City of Albuquerque Planning Department

# MEMORANDUM

About **Project #1000184, Old Albuquerque High School, City Landmark  
Site Development Plan related to LUCC 00280-00000-00119 and LUCCS-00-60**

**Re:** Project # 1000184, Old Albuquerque High School: Final Sign-off on Site Development Plans

South Lot - Proposed South Elevation

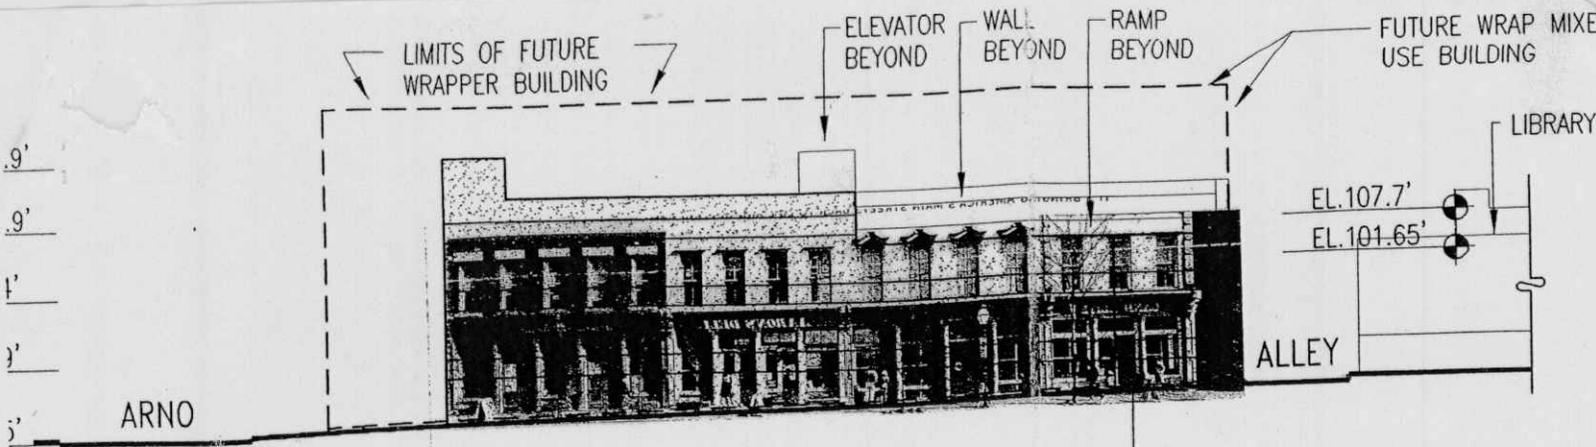
The drawings do not show the LUCC-required murals designed for the parking structure's north and south facades. I attach the applicant's elevations of these facades showing the approved mural designs, without which the design is incomplete and my attest is void.
